## **IMPORTANT RECALL INFORMATION #60227**

SUBJECT: **RECALL CAMPAIGN #60227**  
Quality Axle Hub and Drum Assemblies

## RECALL BULLETIN: 60227

Install Hub  
and Drum  
Assemblies  
with Properly  
Hardened  
Wheel Studs

Figure 1  
Correct Drum  
No Repair Necessary

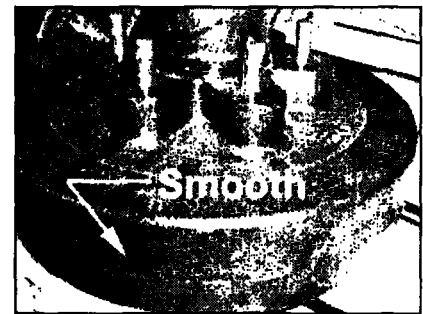
1. Park the conventional or fifth wheel travel trailer on a hard flat surface. Block one wheel, fore and aft, on each side of the conventional or fifth wheel travel trailer.
2. Examine the outside perimeter of the brake drum. If the brake drum has a smooth perimeter, as shown in Figure 1, no further action is necessary. If the brake drum has fins as shown in Figure 2, proceed with the next step.
3. Locate the axle label on the topside of the axle beam. Axle labels matching the serial numbers shown in Figure 3, must have both Hub and Drum Assemblies replaced. Proceed with the Correction section of this Bulletin. If the travel trailer axles have axle label serial numbers different than what is shown in Figure 3, no further action is necessary.

Figure 4

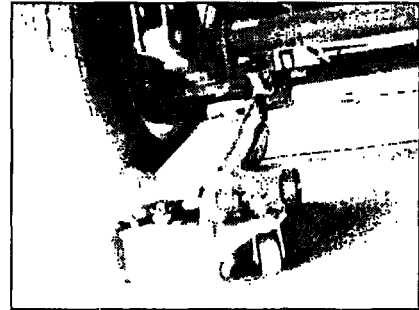
4. Use a floor jack of sufficient capacity to raise one side of the conventional or fifth wheel travel trailer. Locate the floor jack under the spring tie plate below the axle. See Figure 4. Raise the axle just enough to take some of the weight off the wheel.

Figure 5

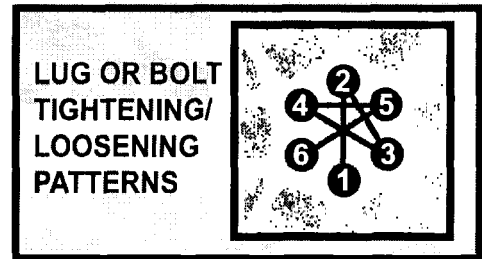
34. Place the wheels on the wheel mounting surface of the Hub and Drum Assemblies. Reinstall the wheel lug nuts, removed in Step 9, with the tapered end of the lug nuts toward the wheel. Tighten each lug nut by hand until the wheels are held against the wheel mounting surfaces. Lower the tires to the ground. Tighten the lug nuts to an initial 60 ft.-lbs. of torque and then to the final torque specification of 80-90 ft.-lbs. Follow the lug tightening sequence identified in Figure 5.
